Road Safety Audit

Intersection Sturt Highway & Airport Road, Renmark
May 2018

Status – Final May 2018

Figure 2: B-Double approved routes around Airport Road (RAVnet, May 2018)

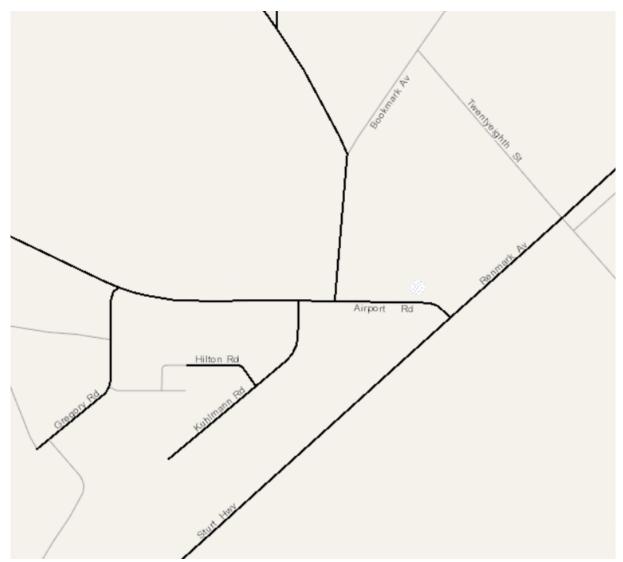
Figure 2 shows the currently B-Double approved routes at the intersection and in the immediate vicinity. The intersection is currently not approved for general Road Train, B Triple or PBS level 2B use at this stage, however consideration needs to be given to future approval of these vehicles types with any upgrades that are considered.
